INFORMAL GROUP ON GASEOUS FUEL VEHICLES
Within the UN GRPE (WP29)
PROPOSED AMENDMENT GFV-04-02

Regulation name and reference number: Regulation 115

Proposed amendments to R115 on mainly:

- ✓ emission test procedure;
- ✓ chassis dynamometer setting;
- ✓ maximum time the system operates on petrol (switch over time) during the Type I test.

Figure 1
NON-INTRUSIVE RETROFIT SYSTEM APPROVAL – FLOW CHART

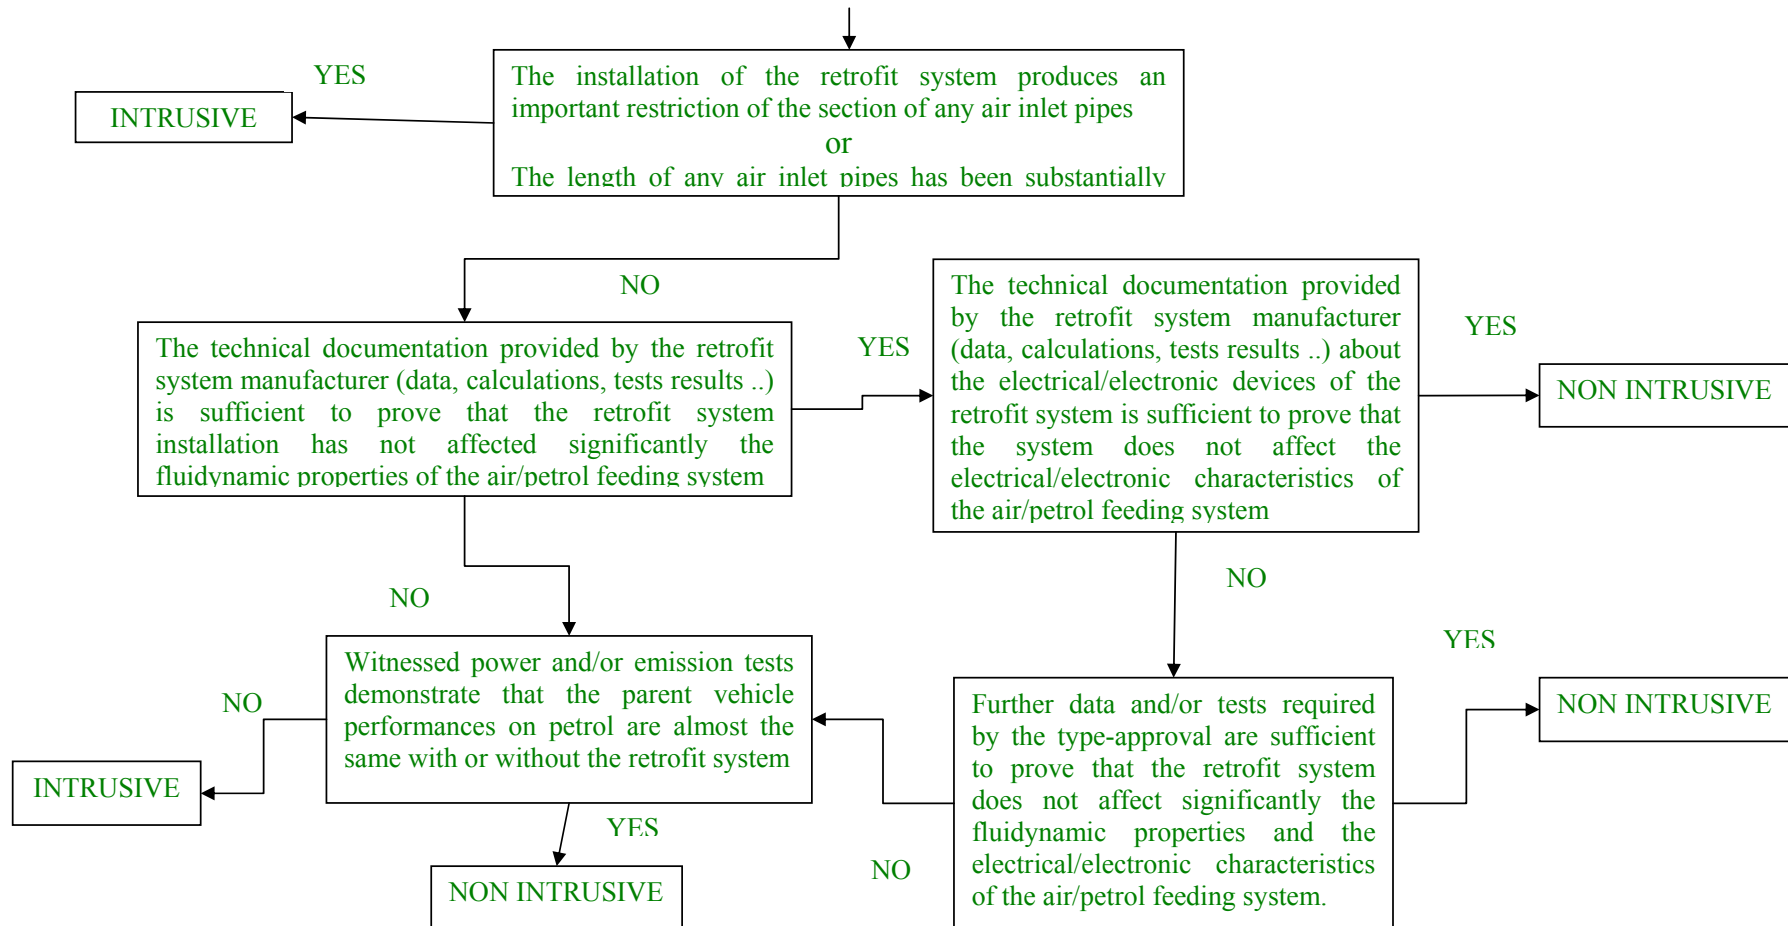
- 6.1.2.2. **In order to prove that the retrofit system is "non intrusive", as defined in paragraph 2.1.5., the system manufacturer shall provide data and/or engineering evaluations which adequately demonstrate that the **performance of original air and petrol feed system to the engine** **not affected by the installation of the retrofit system.** **For the approval of a retrofit system as "non-intrusive", the flow chart provided in figure 1 shall apply.****

AEGPL is firmly convinced that the “non-intrusive” concept should be kept because there are systems that, by design, do not affect the original emission performance of the cars.

In other words, their mechanical components and electric/electronic devices are designed also with the view to avoid any disturb to the original petrol cars components and devices.

However, in order to prevent any misinterpretation and to ensure an harmonized approach by all TAA, AEGPL proposes to improve the non-intrusivity definition and, hence, the related characterization assessment,
